AEROPRAKT SERVICE BULLETIN

No. SB A32-23

WINDSHIELD GLASS REPLACEMENT ON A32 AIRPLANES

Fig. 1

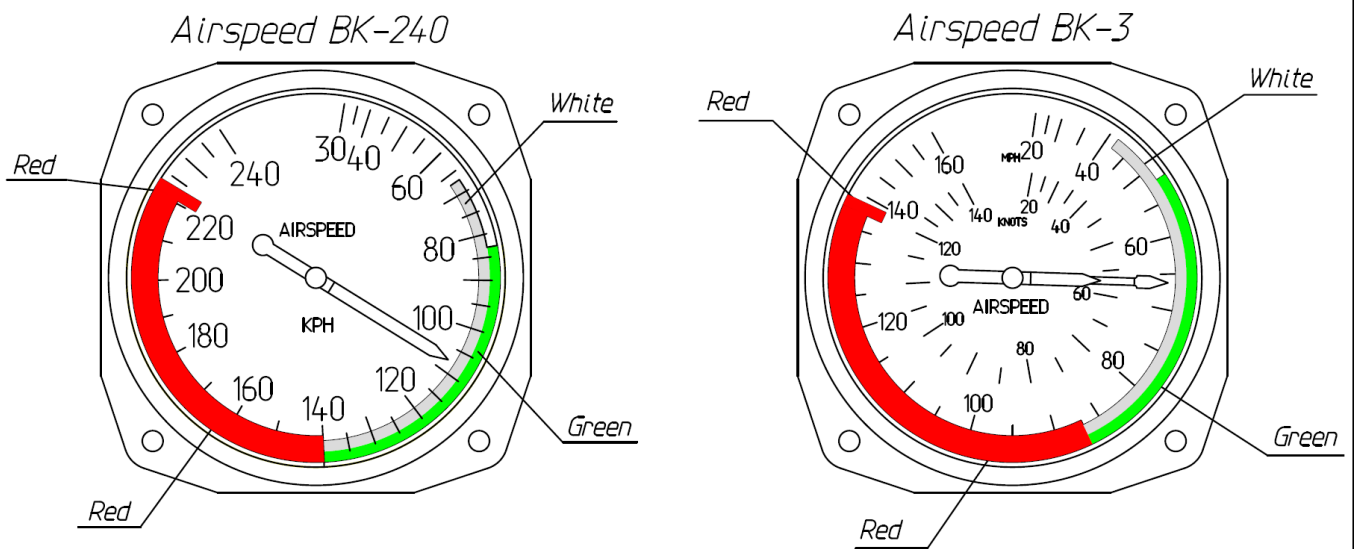
2.1) Before replacing the windshield, put a temporary red speed limit sector $V_{ne} = 140$ km/h (87 mph) to the airspeed indicator (see Fig. 1) and mark this temporary speed limit in the relevant section of the POH (in any convenient way, for example, with a red pencil).
